ADDENDUM NO. 1

Project Owner:	Traverse City Area Public Schools
Project Name:	TCAPS Innovation and Manufacturing Centers
Issue Date:	March 26, 2024

Appendix C – AV Connection Line Diagrams

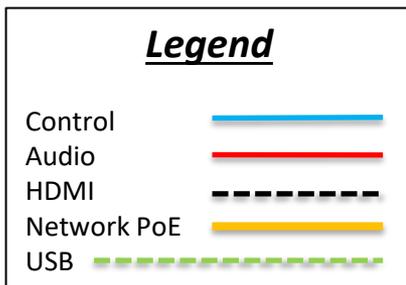
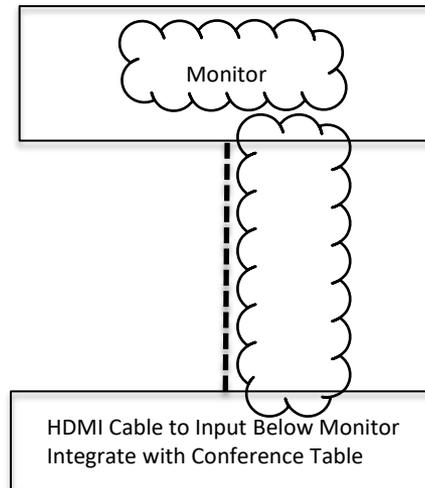
AD1 - 1	Appendix C - Multimedia Line Diagram is hereby revised, reissued and attached hereto.
AD1 - 2	<p>Section 27 41 16- 70 - 2.06 - 2 is hereby revised as follows:</p> <ol style="list-style-type: none"> 2. One (1) 75" LED Monitor(s) shall be provided and installed. <ol style="list-style-type: none"> a. Acceptable Manufacturer(s) <ol style="list-style-type: none"> 1. NEWLINE <ul style="list-style-type: none"> A TT-7523NT-PLUS b. LED Monitor shall meet or exceed the following minimum requirements: <ol style="list-style-type: none"> 1. 75" diagonal 2. Brightness 400 cd/m 3. Rated for 24/7 run-time 4. 8ms refresh rate 5. 3840 x 2160 resolution 6. 16:9 aspect ratio
